APPLICATION NO.	FILING DATE	FIRST NAMED INVENTOR	ATTORNEY DOCKET NO.	CONFIRMATION NO.
10/669,745	09/24/2003	Robert J. Boisselle	1-15957	4502
1678 7590 04/03/2007 MARSHALL & MELHORN FOUR SEAGATE, EIGHT FLOOR			EXAMINER	
			LAZORCIK, JASON L	
TOLEDO, OH 43604			ART UNIT	PAPER NUMBER
			1731	
			MAIL DATE	DELIVERY MODE
			04/03/2007	PAPER

Advisory Action Detail

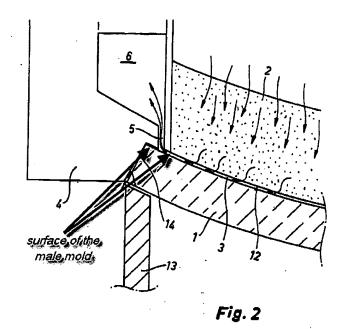
Second, Applicant sets forth arguments on pages 12 and 13 of the instant communication against the rejection of claims 2,3,4,9,15,16, 19 and 21 as rejected under 35 U.S.C. 103(a) over Montonen in view of Posney. Specifically Applicant asserts that the Montonen suction port (5) fails to satisfy "the claimed limitation of at least one peripheral annular groove formed on/in the surface of the male mold". Examiner disagrees.

As clearly depicted in the Montonen reference figure 2 excerpt above, at least mold elements (4) and (2) present a molding surface to the glass sheet (1) as indicated by the annotation lines. Therefore elements (4) and (2) would be conventionally recognized collectively as a pressing face or alternatively as a "surface of the male mold". With this point in mind, it is clear that the peripheral annular groove (5) is formed "in/on the surface of the male mold".
